Request for Additional Information No. 506(5456), Revision 0, Question 14.03.05-39

U. S. EPR Standard Design Certification AREVA NP Inc. Docket No. 52-020 SRP Section: 14.03.05 - Instrumentation and Controls - Inspections, Tests, Analyses, and Acceptance Criteria Application Section: 2.4

### Question 14.03.05-39:

Table 2.4.13-34         Control Rod Drive Control System ITAAC
<u>(2 Sheets)</u>

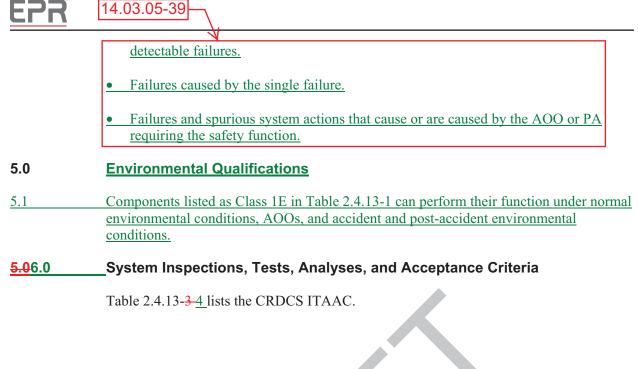
Discuss the basis for not including ITAAC to verify single failure protection for all safety-related systems.

IEEE Std. 603-1991, Clause 5.1, requires that any single failure within the safety system shall not prevent proper protective action at the system level when required. Guidance in the application of the single-failure criterion is provided in Regulatory Guide 1.53, "Application of the Single-Failure Criterion to Nuclear Power Plant Protection Systems," which endorses IEEE Std. 379-1988, "Standard Application of the Single-Failure Criterion to Nuclear Power Generating Station Safety Systems." The applicant provided ITAACs to verify design commitment regarding single-failure protection for safety-related systems such as Protection System (U.S. EPR FSAR, Tier 1, Table 2.4.1-7, Item 4.18), SICS (Tier 1, Table 2.4.2-2, Item 4.10), and SAS (Tier 1, Table 2.4.4-6, Item 4.10). Staff requests applicant to explain why such single-failure protection ITAACs were left out for the other safety-related systems such as Incore Instrumentation System, Excore Instrumentation System, Boron Concentration Measurement System, Radiation Monitoring System, Hydrogen Monitoring System, Signal Conditioning and Distribution System, and Rod Position Measurement System.

U.S. EPR FSAR Tier 1, Instrumentation and Controls Design Features, Displays and Controls commitments and inspections, tests, analyses and acceptance criteria (ITAAC) will be revised to add an ITAAC item for single failure criteria to the following:

- PACS (Section 2.4.5, Item 4.11)
- Boron Concentration Measurement System (Section 2.4.11, Item 4.4).
- Control Rod Drive Control System (Section 2.4.13, Item 4.6).
- Hydrogen Monitoring System (Section 2.4.14, Item 4.3).
- Excore Instrumentation System (Section 2.4.17, Item 4.4).
- Incore Instrumentation System (Section 2.4.19, Item 4.4).
- Radiation Monitoring System (Section 2.4.22, Item 4.3).
- Signal Conditioning and Distribution System (Section 2.4.25, Item 4.7).
- Rod Position Measurement System (Section 2.4.26, Item 4.9).

4.6	<ul> <li><u>The CRDCS is designed so</u> <u>that safety-related functions</u> <u>required for an AOO or PA</u> <u>are performed in the presence</u> <u>of the following:</u></li> <li><u>Single detectable failures</u> <u>within the CRDCS</u> <u>concurrent with</u> <u>identifiable but non-</u> <u>detectable failures.</u></li> <li><u>Failures caused by the</u> <u>single failure.</u></li> <li><u>Failures and spurious</u> <u>system actions that cause</u> <u>or are caused by the</u> <u>AOO or PA requiring the</u> <u>safety function.</u></li> </ul>	A failure modes and effects analysis will be performed on the CRDCS at the level of replaceable modules and components.	<ul> <li><u>A report concludes that the</u> <u>CRDCS is designed so that</u> <u>safety-related functions</u> <u>required for an AOO or PA are</u> <u>performed in the presence of</u> <u>the following:</u></li> <li><u>Single detectable failures</u> <u>within the CRDCS</u> <u>concurrent with</u> <u>identifiable but non-</u> <u>detectable failures.</u></li> <li><u>Failures caused by the</u> <u>single failure.</u></li> <li><u>Failures and spurious</u> <u>system actions that cause</u> <u>or are caused by the AOO</u> <u>or PA requiring the safety</u> function.</li> </ul>
